City of Portland, Oregon
Bureau of Development Services
Land Use Services
FROM CONCEPT TO CONSTRUCTION

STAFF REPORT AND RECOMMENDATION TO THE DESIGN COMMISSION

CASE FILE: **LU 16-129367 DZM**
2211 SW 4th Avenue Apartments
PC # 15-114048
REVIEW BY: Design Commission
WHEN: June 16, 2016 at 1:30PM
WHERE: 1900 SW Fourth Ave., Room 2500A
Portland, OR 97201

① Grant Street Elevation
3/32" = 1'-0"

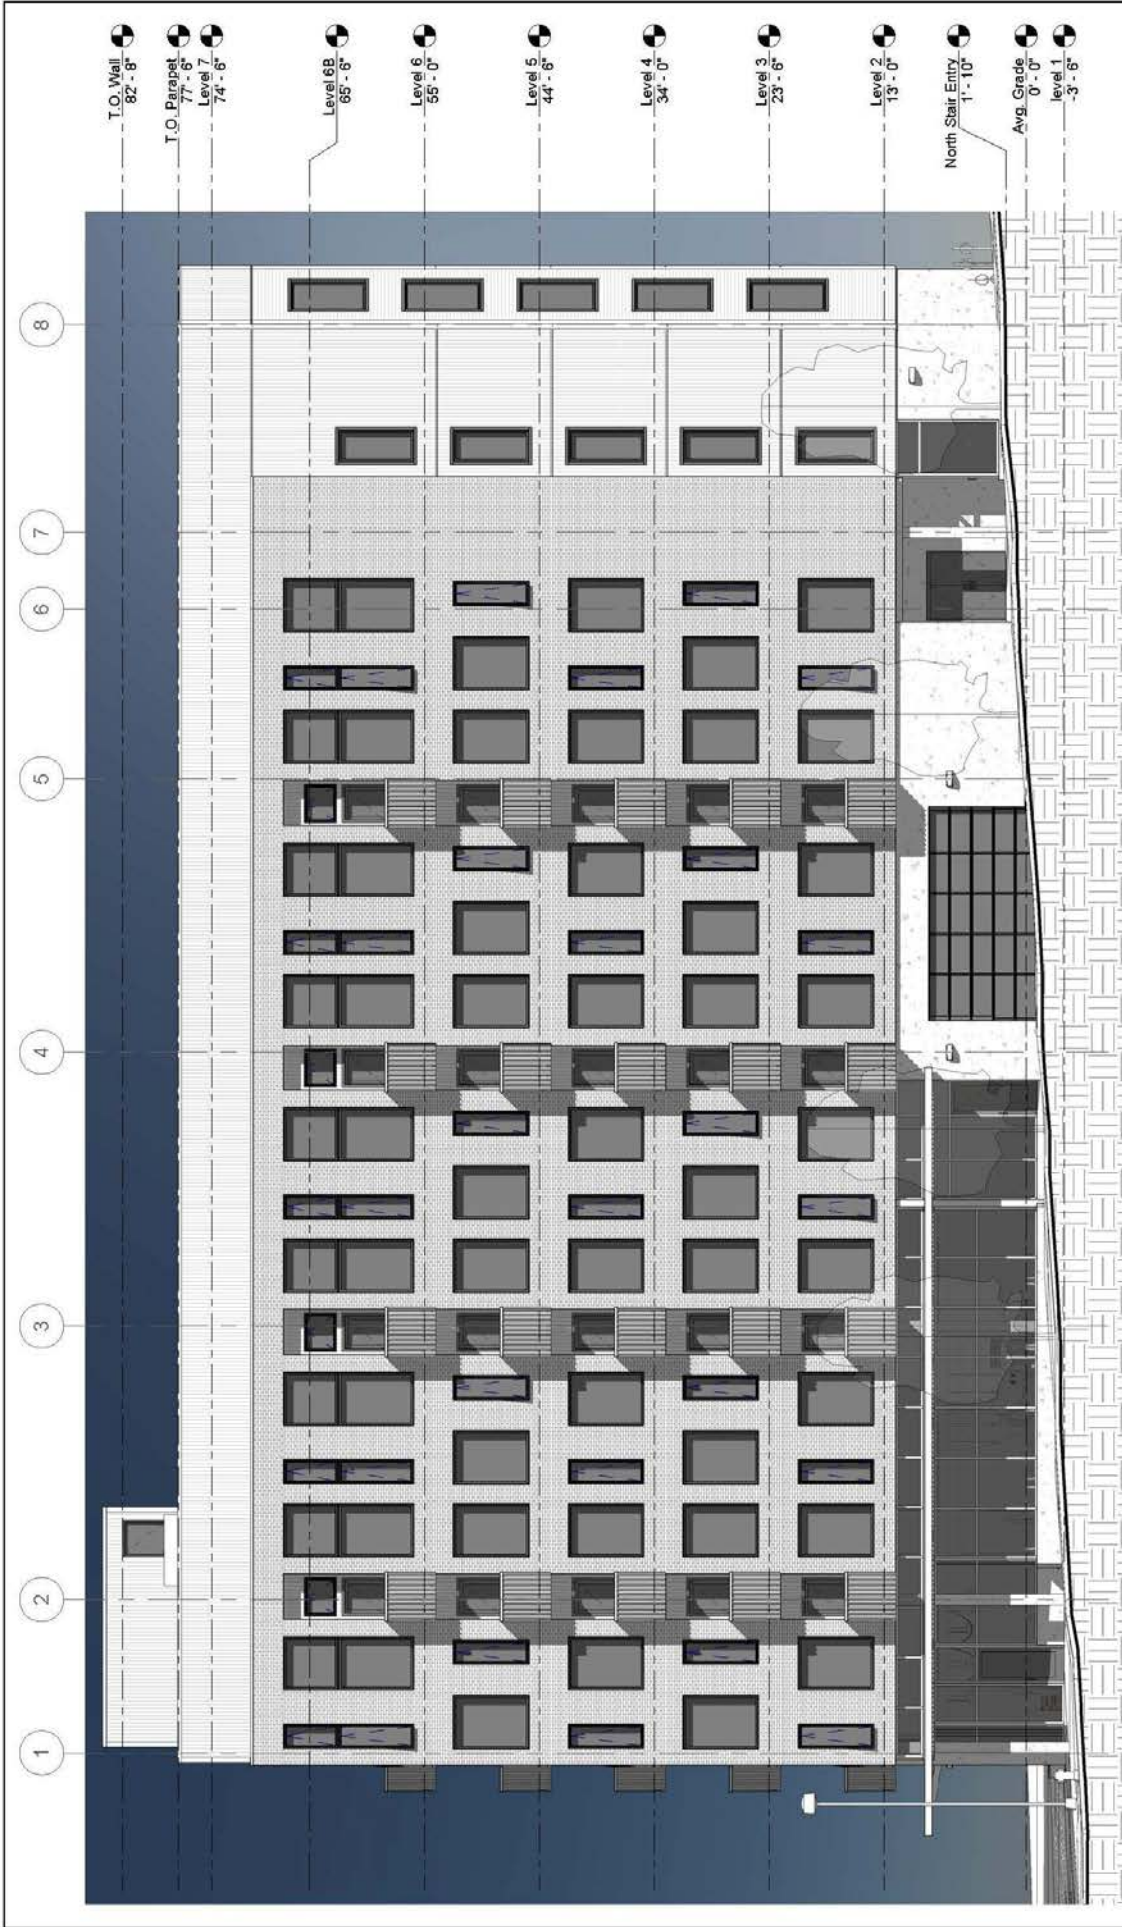
- While the applicant has configured the southeast stair further inward and activated the corner with a bike lobby for stair and elevator access to the second floor, the north western corner of the building at the SW Grant Street frontage has deactivated the opportunity to provide for more active spaces and eyes on the street at this unique corner. Moving the stair tower further inboard along either the street frontage or to the rear elevation, would allow residential units to wrap these corners and provide highly desirable views as well as façade articulation which would improve the rear elevation’s composition.

While non qualifying glazing on SW Grant Street does allow visual connections into the western egress stair corridor, additional active space functions could be improved along this frontage. Additional opportunities exist such as relocating the stair tower and/or eliminating parking stalls adjacent to the property to provide additional ground floor commercial space, and would improve the street frontage and eliminate this Modification Request. *Therefore, these Design Guidelines are not better met by the current proposal.*

Staff agrees that the aggregate of window area above the required minimum across both facades is a positive aspect to the building's overall ground level experience at the street. And additional clear window area into non-compliant areas such as into the stairwell does provide some visual interest, as opposed to a solid wall for instance. However, the specific experience of the pedestrian along SW Grant Street does not take the SW 4th Avenue block frontage into consideration. Ultimately though, the ground floor program can be reconfigured to provide more active use area by removing parking stalls and/or reconfiguring the western stair tower to provide standard compliant office or retail space along SW Grant Street.

1 South Elevation
3/32" = 1'-0"

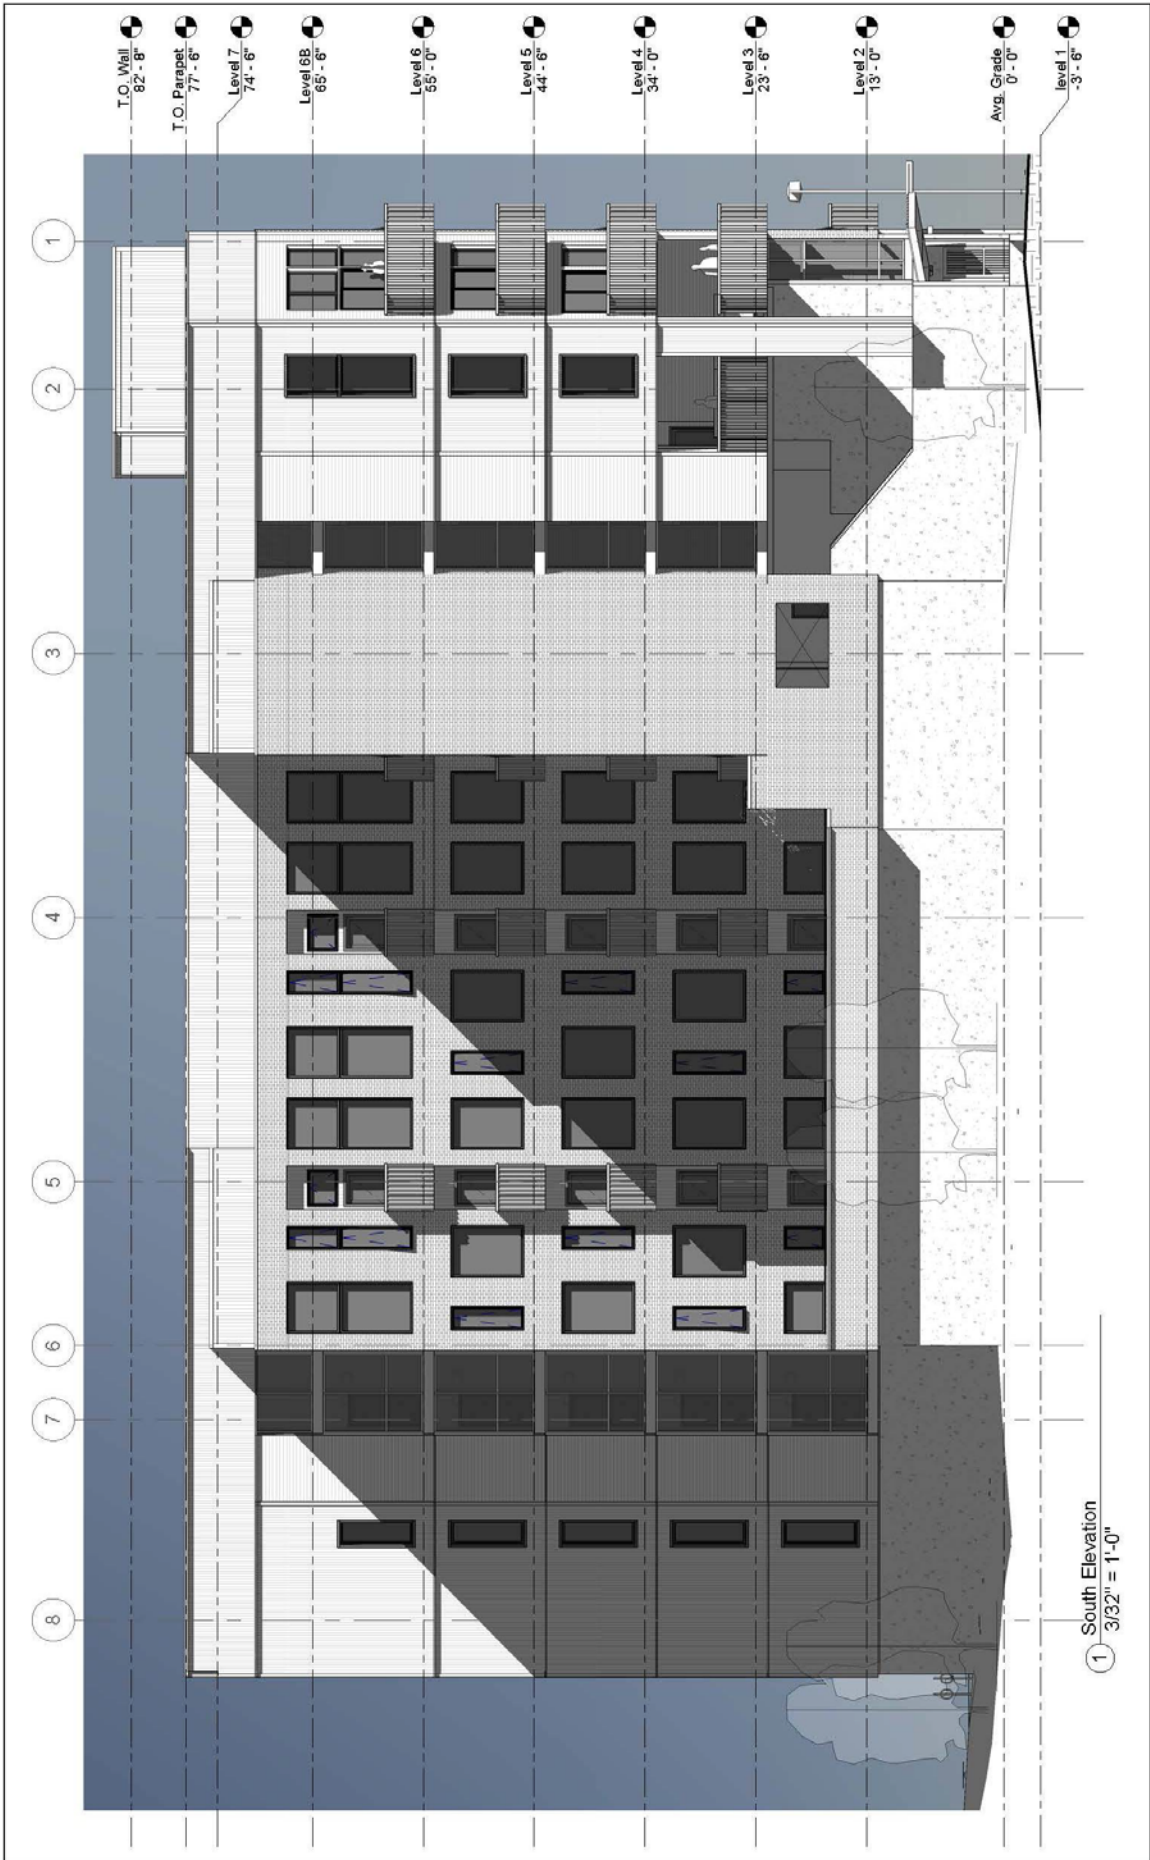
Findings: The south elevation of the building is a critical frontage with as high or higher degree of visibility than the street elevations, and effectively a gateway into the downtown core of the City of Portland. Therefore, there is a high expectation that this elevation be successfully detailed and composed effectively. The overall composition of the building has improved since the June 2015 DAR, particularly the introduction of board form concrete and standard sized brick masonry. There are three areas however that need additional design refinement: 1) large scale metal paneled corners; 2) foundation frontage facing freeway; and 3) acoustic concerns.

- a) The large scale introduction of metal panel wrapping the corners at both the northwest and southeast corners of the building, greatly accent the mass of the building at the rear south facing elevation along the freeway. Additional consideration should be given to wrap these corners in brick, further activating the northwest corner with residential units and balconies, and consider further chamfering the corners to better utilize the floor plan of this site's unique shape.

- b) The large scale concrete foundation frontage facing the I-405 freeway is an additional concern for this southern exposure of the rear foundation. In part due to the slope of the site down to the I-405 freeway, the amount of concrete foundation exposure appears far too massive and will need to be mitigated with more architectural or artistic moves, not just landscaping. Possible solutions include terracing the concrete exposure to allow additional massing relief, and/or articulating the concrete pattern, and/or exploring a public art opportunity at this location with the Regional Arts and Culture Council.

- c) Acoustic concerns for the south facing elevation freeway exposure also remain. Lastly, while the massing reduction in this area may have been intended to be responsive to concerns raised at the June 2015 DAR, there is concern that south facing residential units may have an enhanced freeway noise condition due to the inward massing of the L-shaped building partii above the podium level. Alternative approaches could include utilizing this area to expand upon currently tight building restraints such as interior corridors, elevator lobbies, bike parking, unit size, and unit balconies.
